COUNCIL AGENDA REPORT

SUBJECT: CONSIDER AN APPEAL OF A PLANNING COMMISSION DECISION APPROVING A REQUEST TO DEMOLISH A SINGLE FAMILY RESIDENCE AND TO CONSTRUCT A NEW RESIDENCE ON PROPERTY ZONED R-1:8. APN 409-15-021 ARCHITECTURE AND SITE APPLICATION S-07-188 PROPERTY LOCATION: **14329 MULBERRY DRIVE** PROPERTY OWNER/APPLICANT: HALLMARK COMMUNITY SERVICES APPELLANT: DENNIS CHAMBERS

TOWN OF LOS GATOS
PLANNING COMMISSION STAFF REPORT
Meeting Date: August 27, 2008

RE: 14329 Mulberry Drive

Recommended Front Elevation

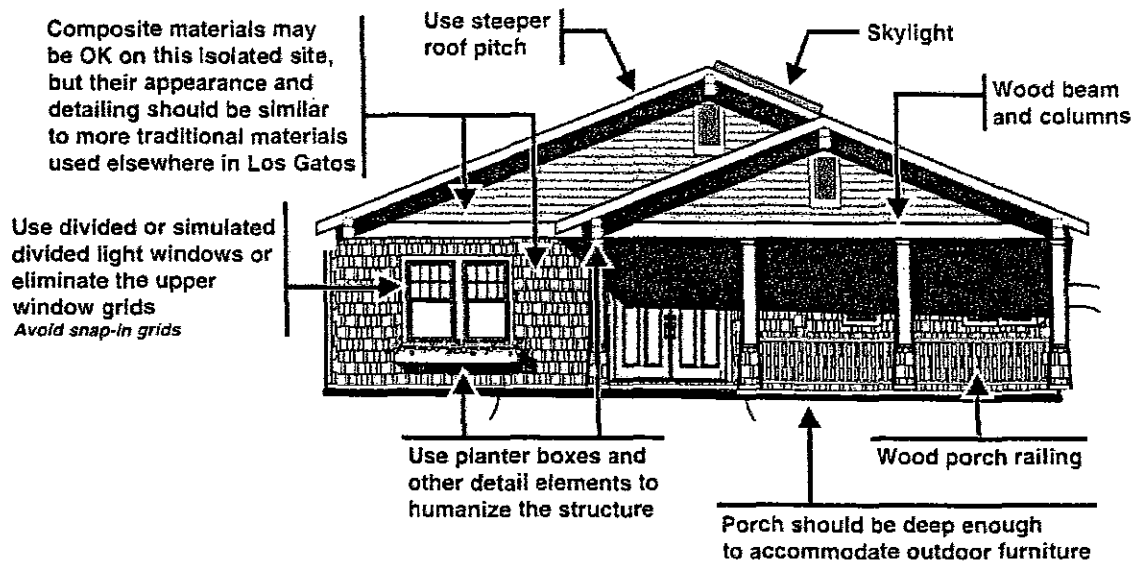
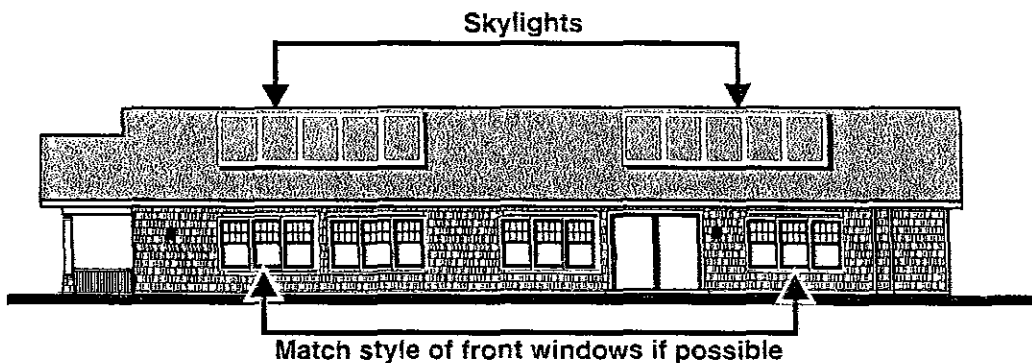
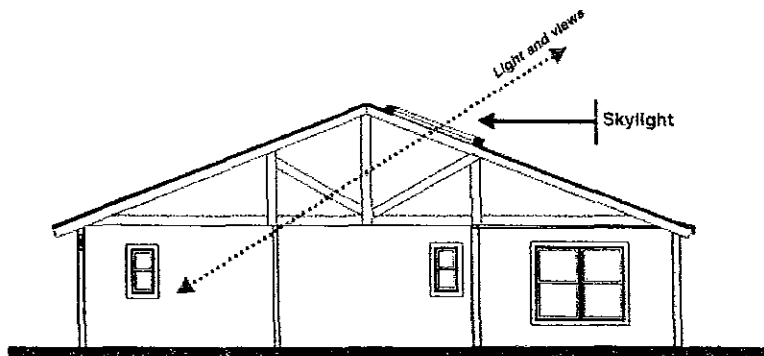
5. Increase the roof pitch. With respect to achieving the goal of allowing bedridden residents to look out at the sky, the preferred solution, in my judgement, would be to provide clear skylights along the north side of the roof. This would provide natural light to the interior and allow views out. It would also have the least impact on the residential scale and character of the house.

EXHIBIT B:
SITE MAP

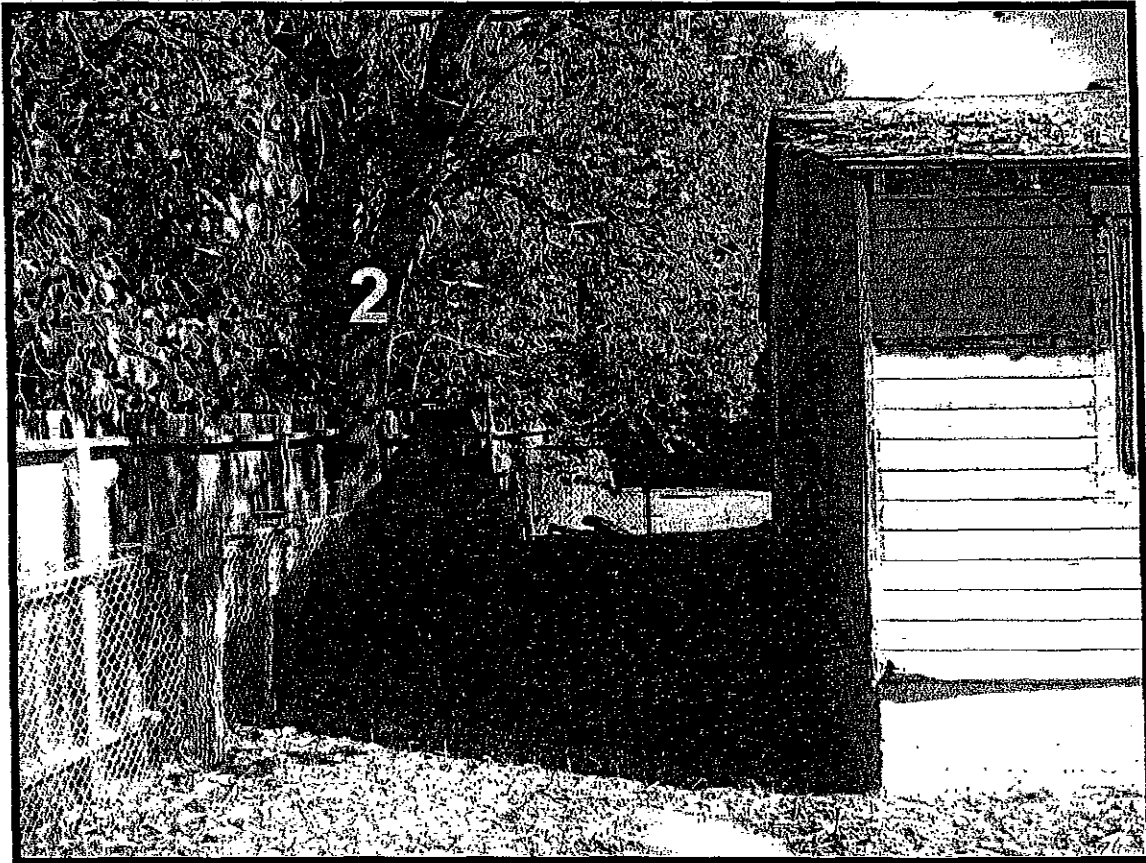
Tree #7 is also exposed to potential significant impacts by installing a new driveway. To minimize root damage, plans should be redesigned to the driveway edge is at least four to five feet from the closest edge of its trunk.

To verify that the design can achieve the trees' protection, Sheet 2 (Preliminary Grading & Drainage Plan) should show existing site elevations, as well as the horizontal and vertical elevations of the base of the trunks of **trees #2 thru 5**.
